Planning Commission
May 19, 2026 - 6:00 PM
233 South Main Street, Monroe, Ohio

I. Case No. 2026-5-4—PUBLIC HEARING, Consideration of a Site Plan and Conditional Use Permit for the Monroe Municipal Services Center

MONROE MUNICIPAL SERVICES CENTER

CONDITIONAL USE AND SITE PLAN

N2 COMPILED EAST ELEVATION

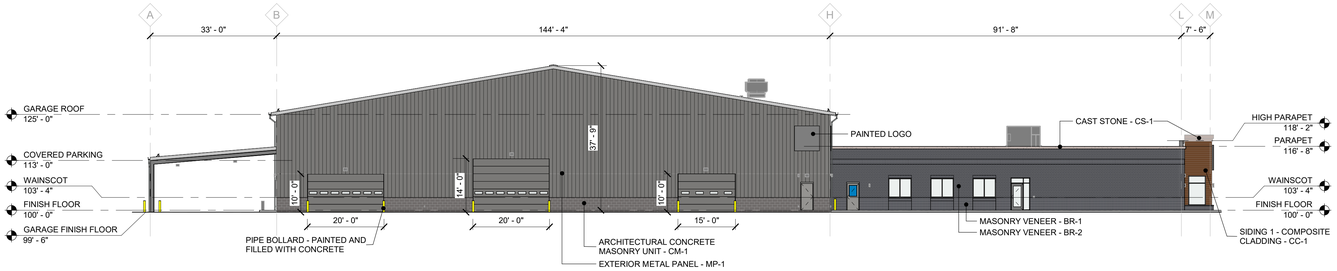
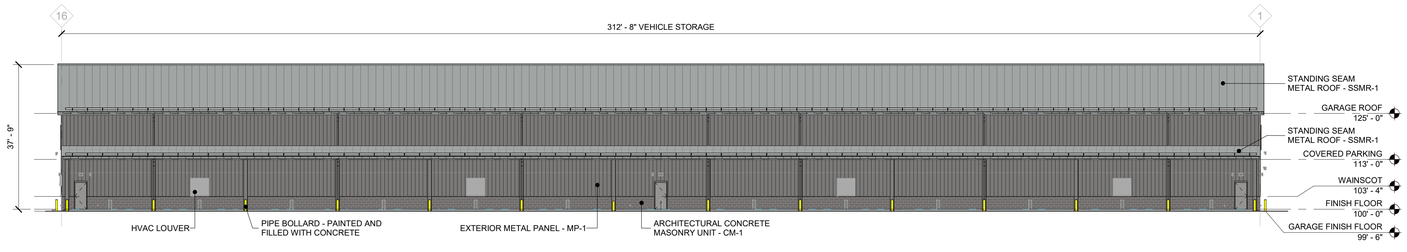
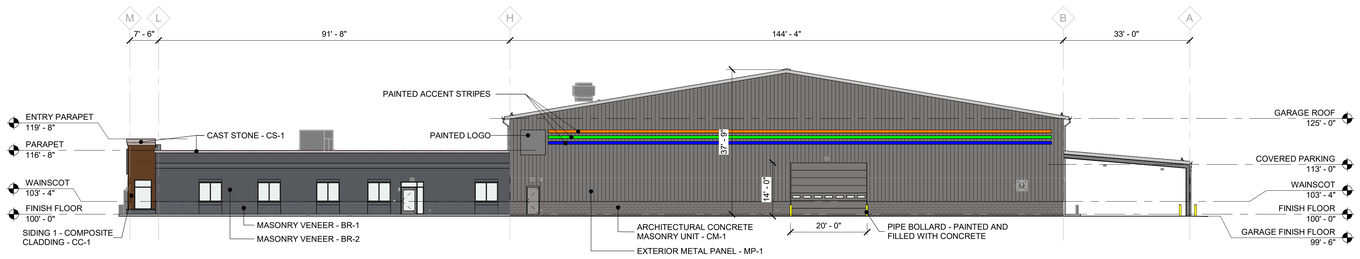
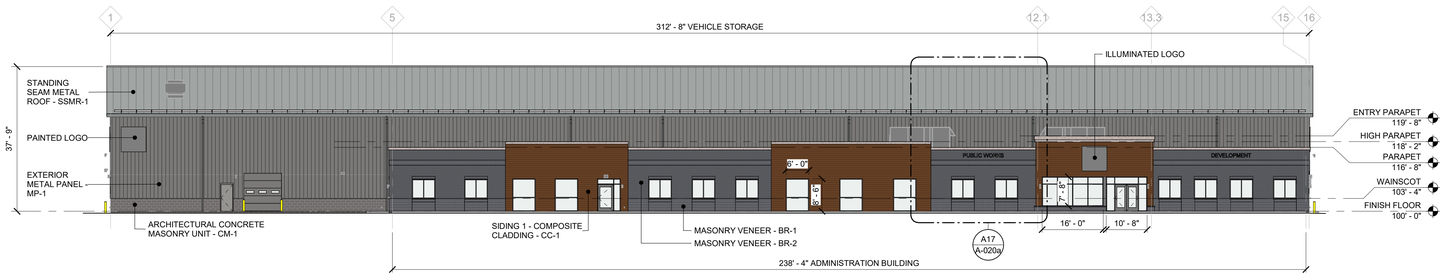
- **Architectural**
  - Base, Body, Cap Design Elements.
    - The applicant must show the Base, Body, Cap percentages on the elevations to ensure compliance.

- Revise each elevation to show the base, body, and cap percentages to ensure compliance.
    - All landscaping must meet all minimum species and size requirements and be detailed appropriately on the plan.

1 E-002 **SITE PHOTOMETRICS**
1" = 30'-0"

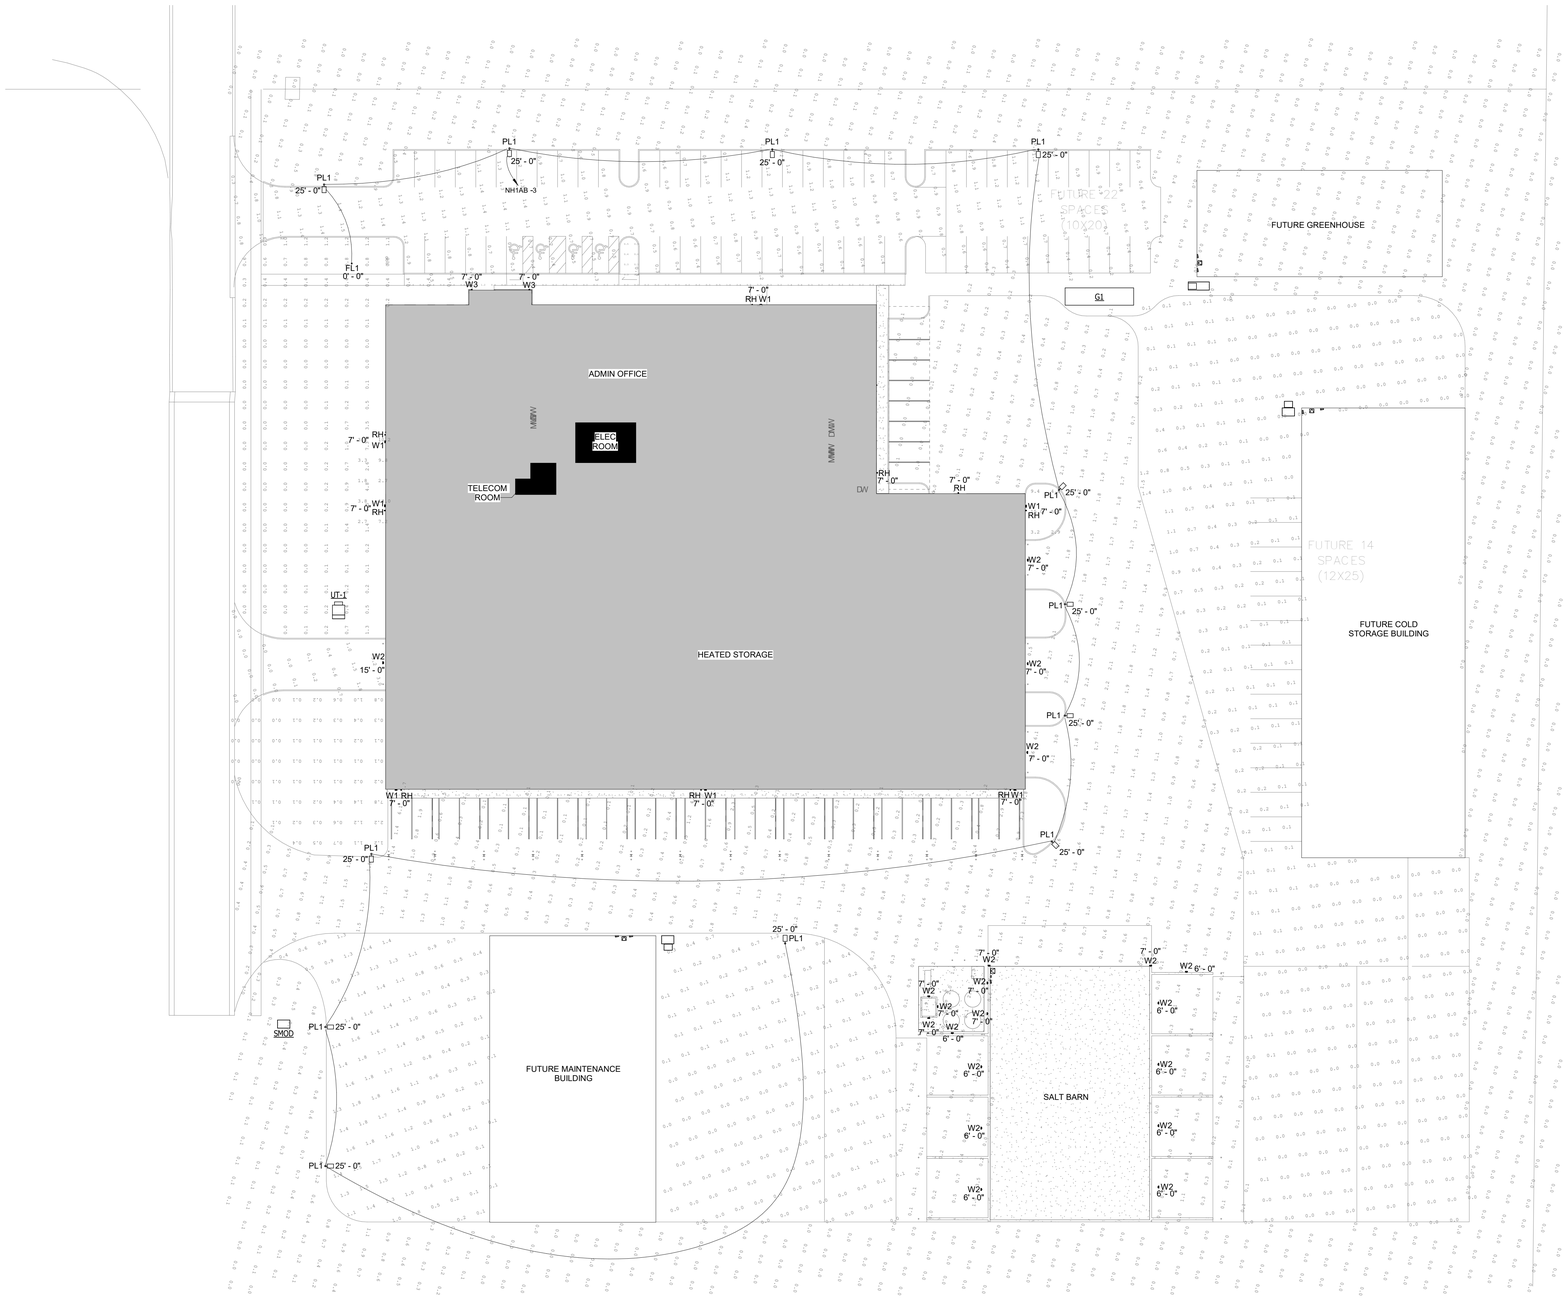
- **Photometric**
    - Illumination is required consistently across the site and shall be designed so as not to create dark spots that may create safety issues in such areas as vehicular use areas and connecting pedestrian paths.
        - The photometric plan is missing the southern property line. Please revise.

- Revise the photometric plan to show the southern property line.
    - Show a line-of-sight diagram to ensure proper screening for rooftop equipment.
